Exhibit MB-50

Exhibit MB-50 aTypical Road

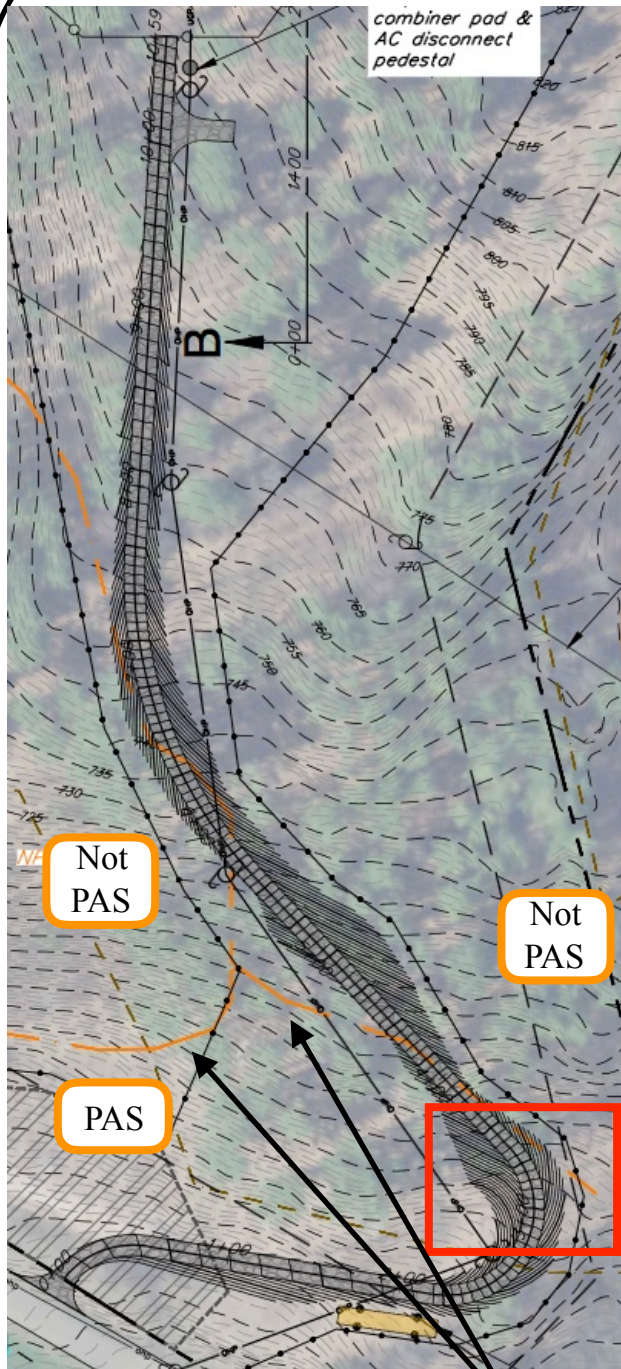
These clippings are from the first and second Site Plans (these are the only site plans with 1 ft minor contours)

This stretch of the Access Road is on PAS

The soil boundaries are Orange Dashed Lines

None of the PAS from this stretch of the access road is excavated.

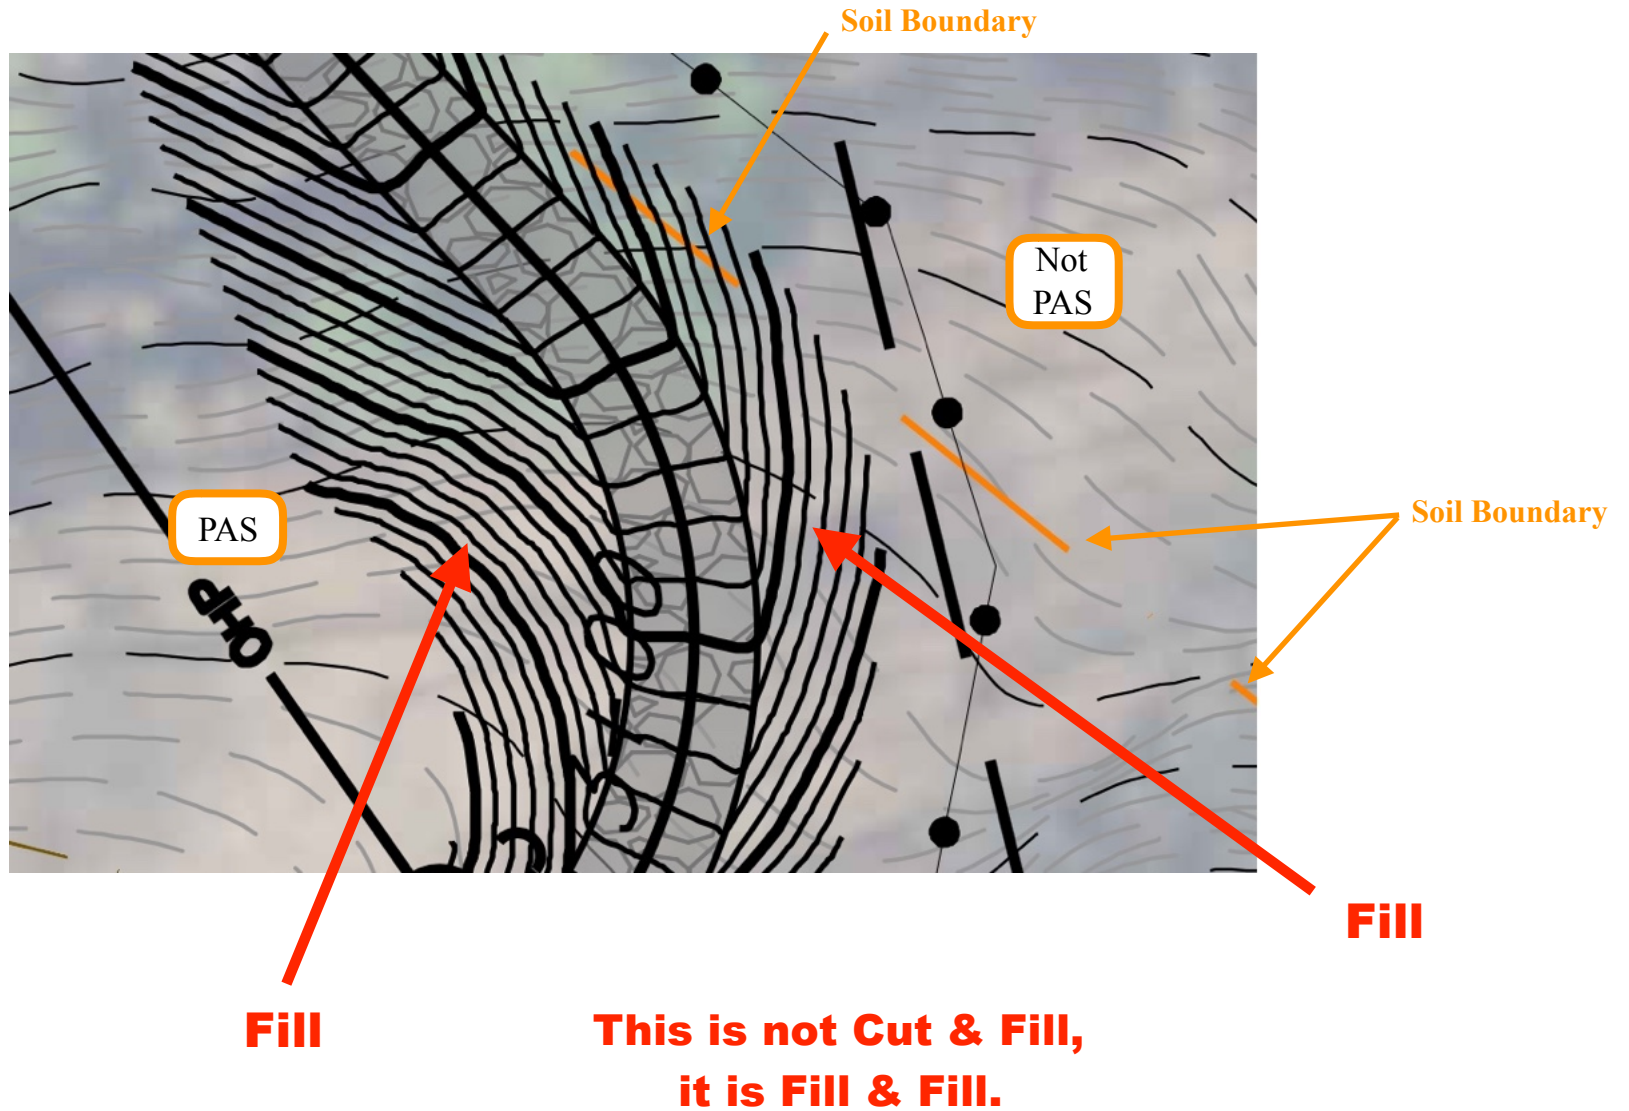
This section of the road is built up with fill.

The roadbed is on the top of a Berm

Pre-construction of the road: If you walk from A to B, you would descend 2 ft (from 669 to 667).

Post-construction of the road: If you walk from A to B, you would gain 6 ft (from 669 to 675).

Post-construction of the road: If you stand at B, your feet are 8 ft above the original elevation.

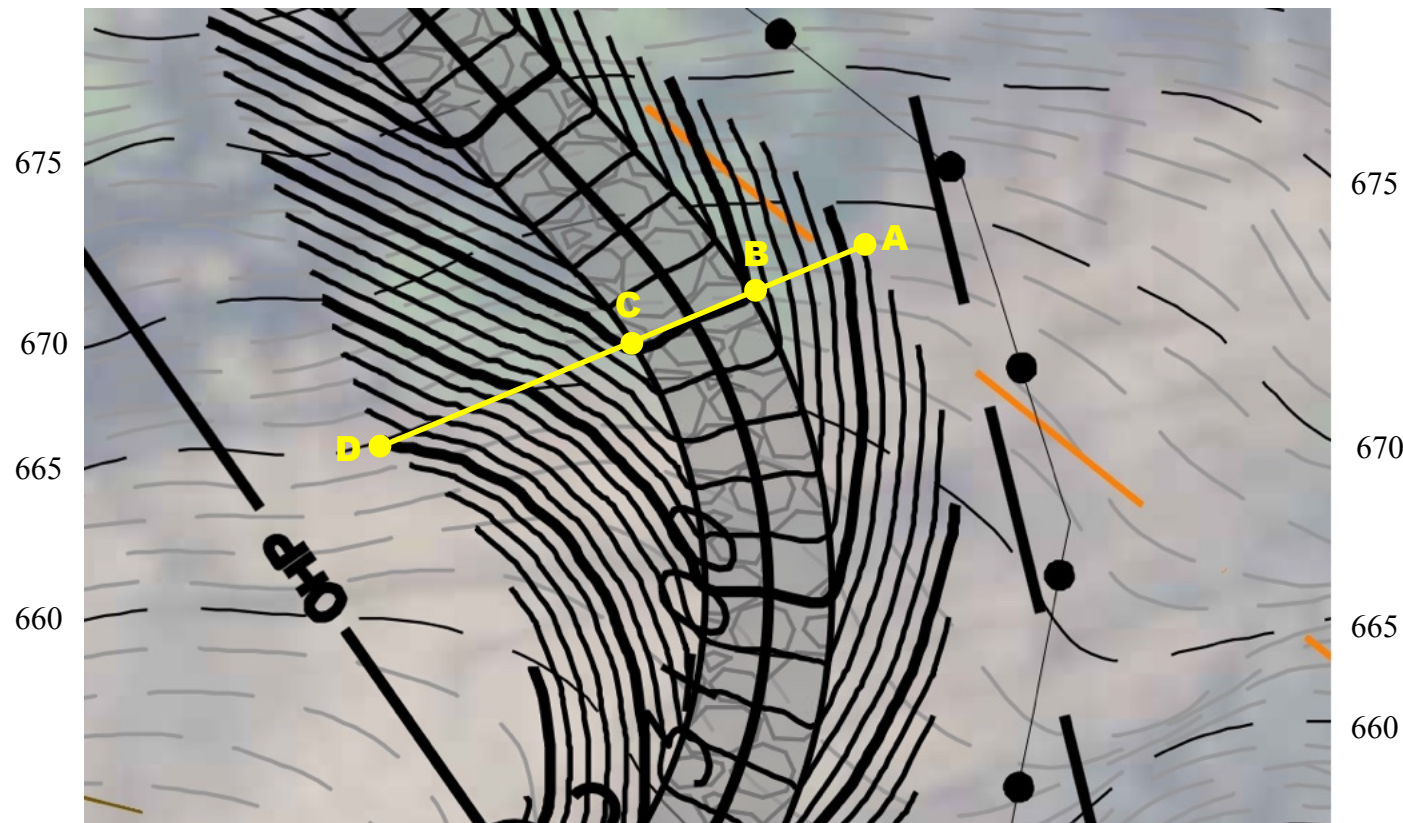
Post-construction of the road: If you stand at C, your feet are 9 ft above the original elevation.

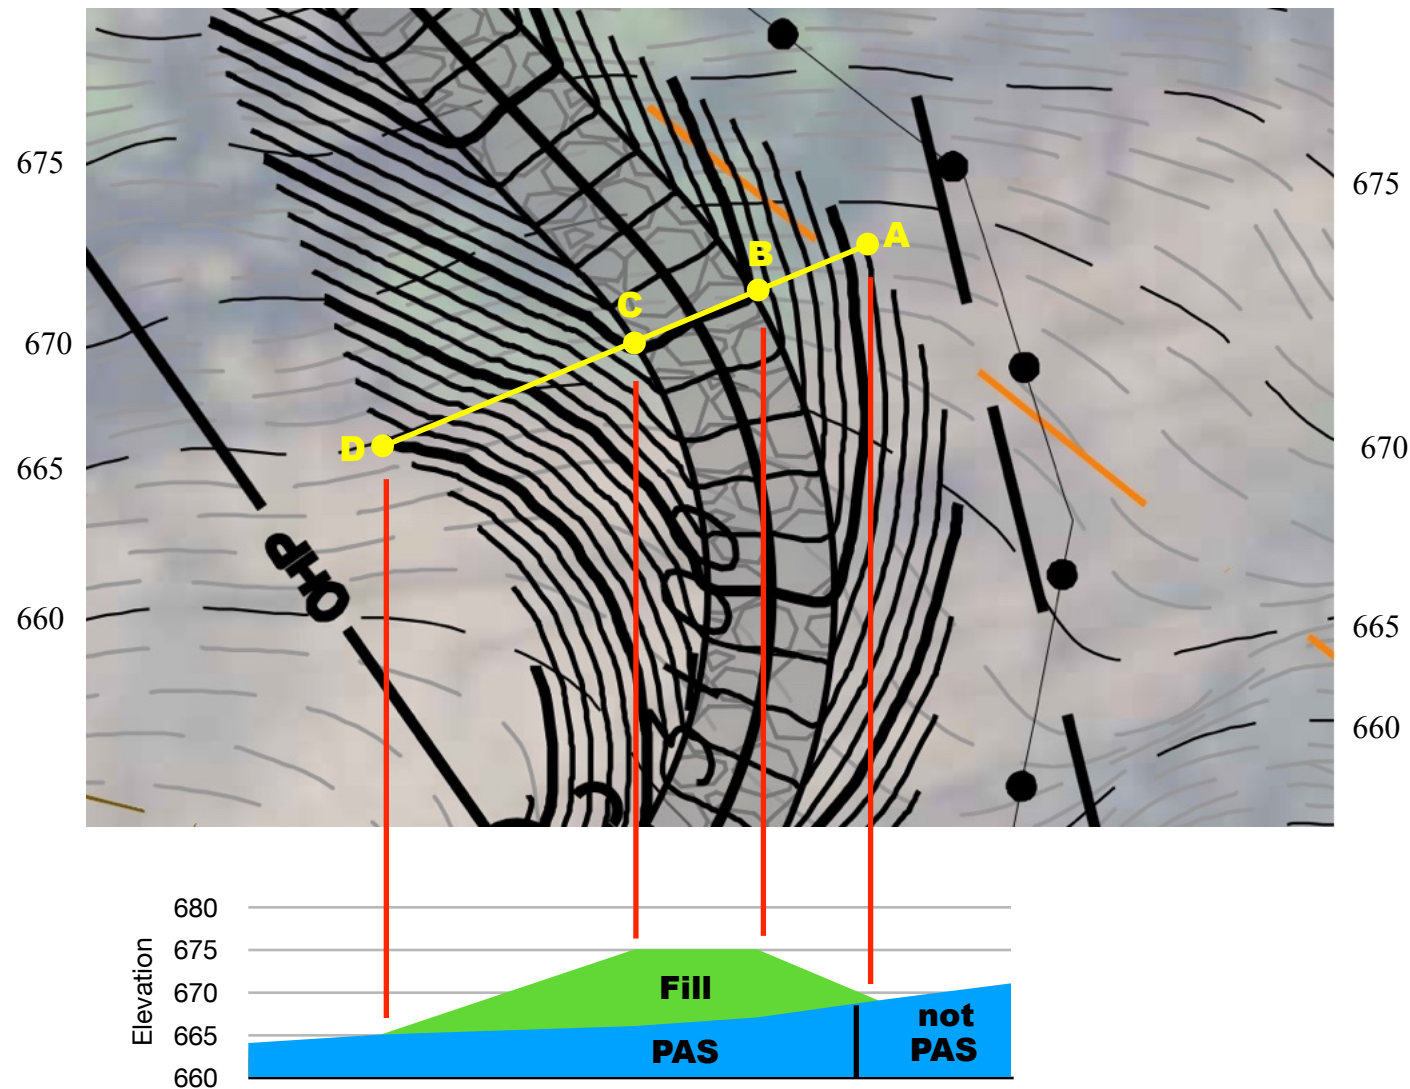
Fill is used to create a Berm on top of PAS

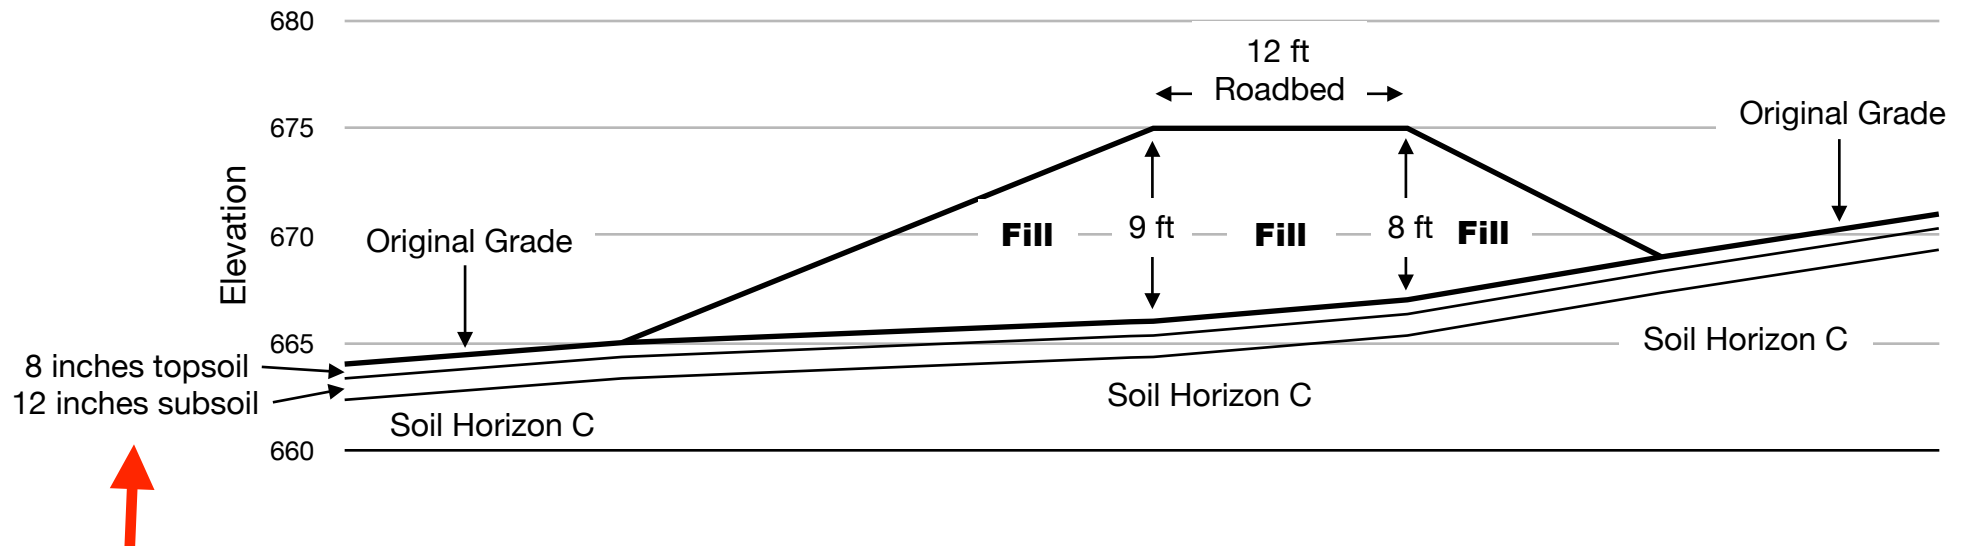
A bit more detail showing PAS Topsoil and Subsoil buried under fill.

Horizons A and B are typically 20 inches deep on Buckland PAS.

If the PAS topsoil and subsoil under the berm were to be stockpiled, the PAS storage area (as drawn on the Site Plan) would be undersized by about two orders of magnitude.

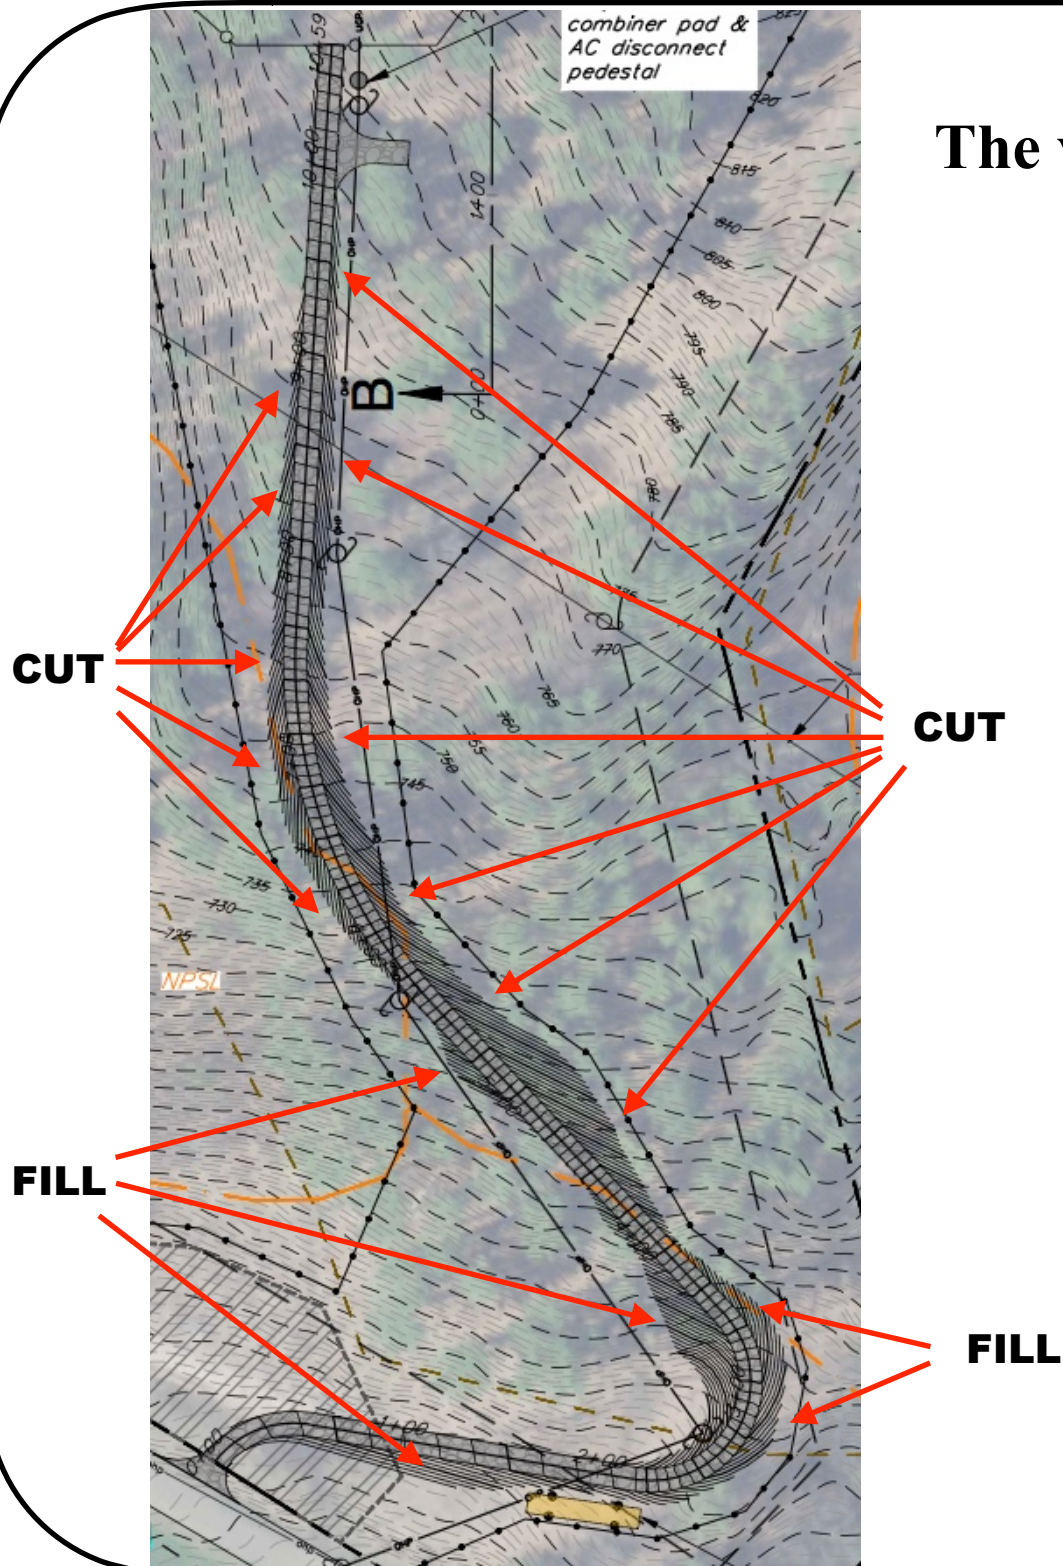
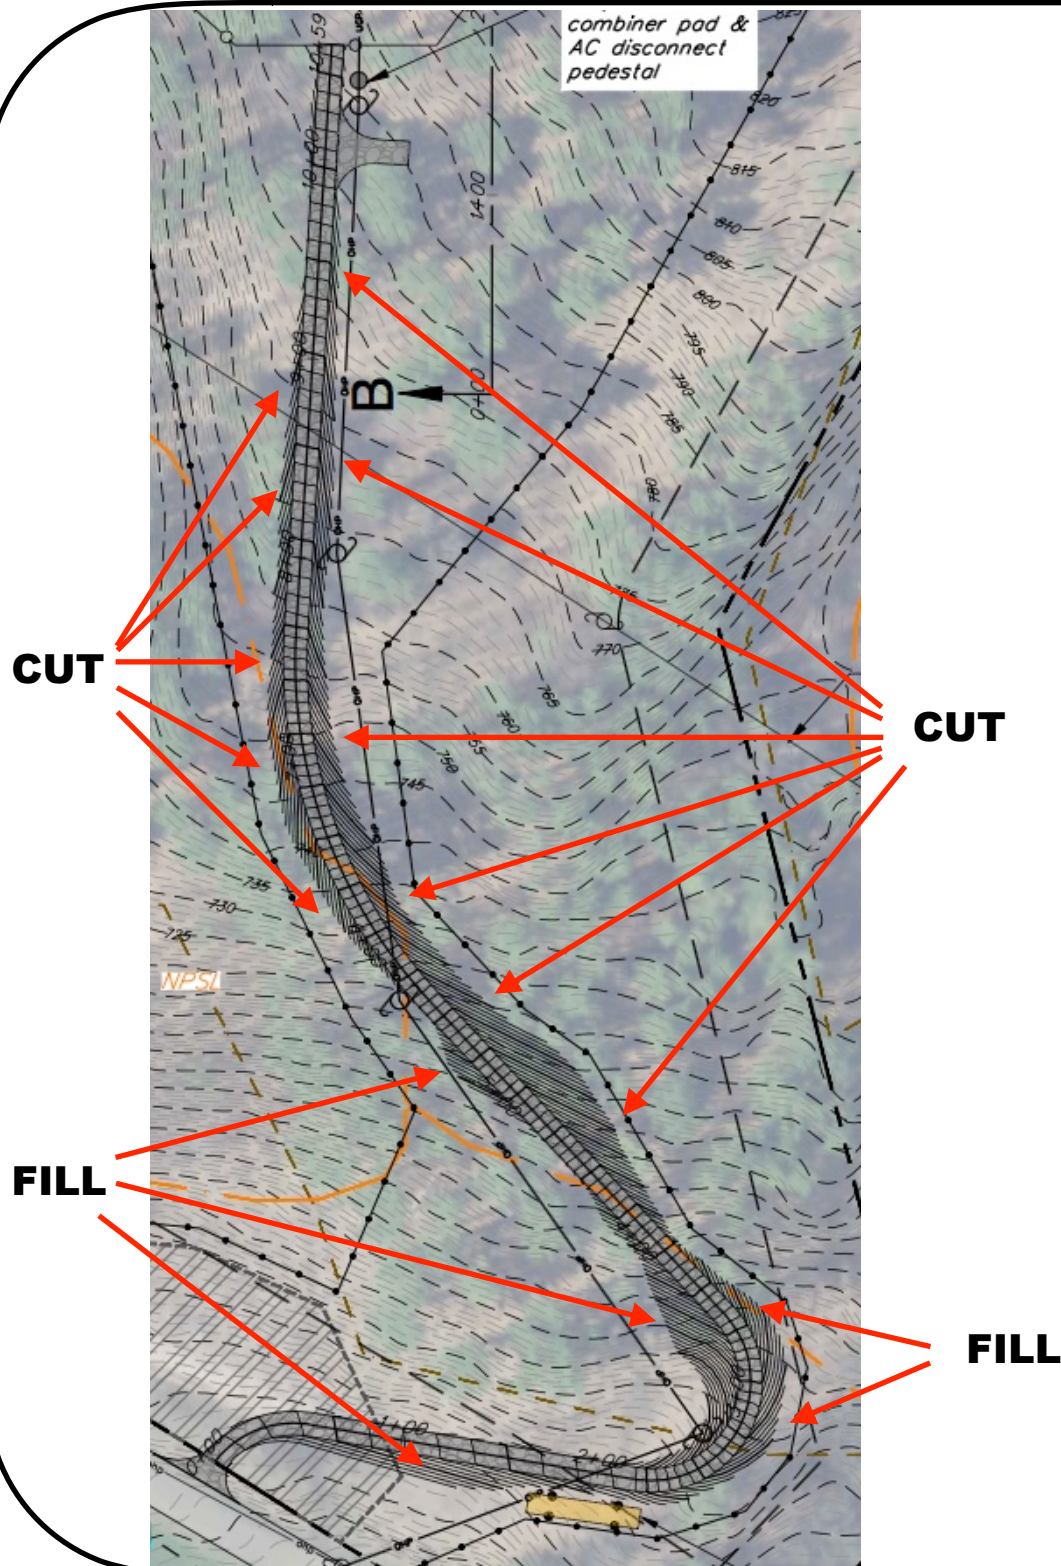
A trench is created when the fill is cut from both sides of the road.
